Product Safety Recall

Gorilla Extension Ladder 150kg Industrial - EL12/21-I. Manufactured between December 2006 and October 2014. Available for sale from January 2007 to November 2014.

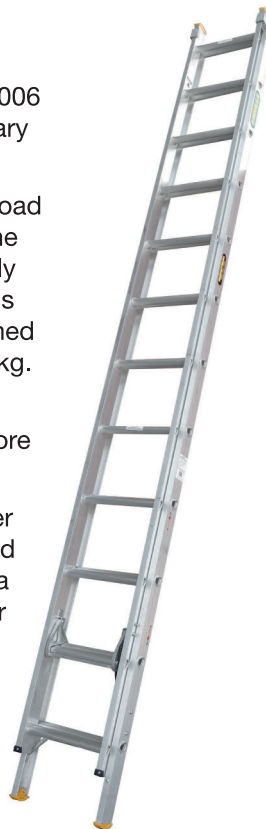
Defect: The ladder does not perform to 150kg load capacity as claimed on the packaging and on the load rating label. Consumers may mistakenly rely on the claimed load rating to assess whether it is safe for them to use. Recent testing has confirmed that the ladder should have a load rating of 120kg.

Hazard: There is a possibility of a fall injury occurring if the ladders fail while loaded with more than 120kg.

What to do: Consumers must not use the ladder for loads of more than 120kg. Consumers should contact Hartman Pacific in order to arrange for a new rating label and load rating stickers for their existing ladder, or call Customer Service if you believe that you will use the ladder with loads greater than 120kg.
